**RESOLUTION OF THE CITY OF LAUREL CITY COUNCIL GRANTING A VARIANCE FOR GOLDBERG SPORTING ESTATES SUBDIVISION, FIRST FILING, FOR THE USE OF A LOW-PRESSURE SEWER SYSTEM**

Re: Goldberg Sporting Estates - Sewer Impact Analysis - Revision 6

Re: Petition for Variance from City Code for Goldberg Sporting Estates – Low Pressure Sewer System

### Scenarios

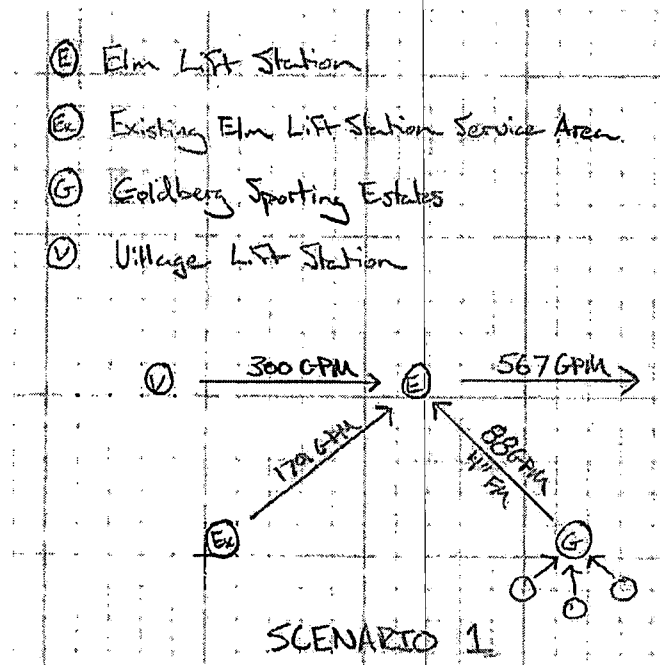
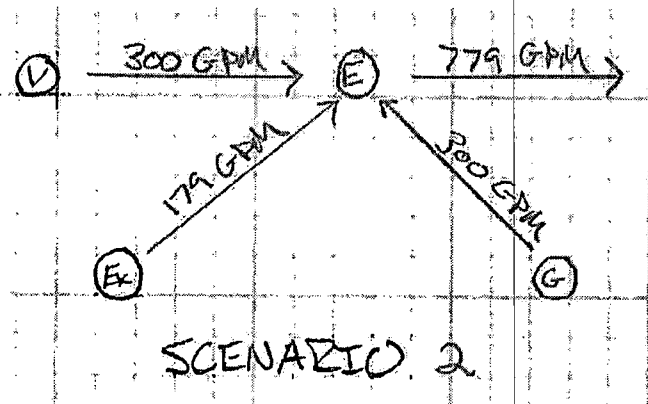
Scenario 1- Proposed development utilizing LPSS with individual pumps having a 4" force main discharging to the existing gravity sewer in the Elm Service Area. Includes replacement of 8-inch gravity main between MH 332-MH 335 with 10-inch gravity main.

Scenario 2- Proposed development utilizing gravity sewer and a single large lift station at 300 gpm discharging to the existing gravity sewer in the Elm Service Area. Includes replacement of 8-inch gravity main between MH 332-MH 335 with 10-inch gravity main.

Based on the two scenarios visually presented above the Elm Lift Station, with the pump replacements in 2015 and 2021 to provide 600 gpm capacity as recommended in the Morrison-Maierle report can support Scenario 1 without modification. That would leave the existing wet well, pumps and ancillary equipment in place and sized properly to service the existing neighborhoods along with the new GSE development and all potential future development along East 8<sup>th</sup> Street. Under this scenario it may be beneficial to replace the last Gorman-Rupp pump with a matching Homa pump as was installed in 2021. This would provide matching equipment for the facility and extend the useful life of the pumping equipment impacted by the proposed GSE development.

Should the City decide that a conventional lift station be used for the GSE the facility would be sized to accommodate 300 gpm peak flows. Under Scenario 2 you can see it would require the entirety of the Elm Lift Station, wet well and ancillary equipment included, to be upgraded and replaced to accommodate a design flow of 779 gpm at peak. It is our opinion that this is an unnecessary upgrade when flows can be controlled through a LPSS servicing the GSE development area.
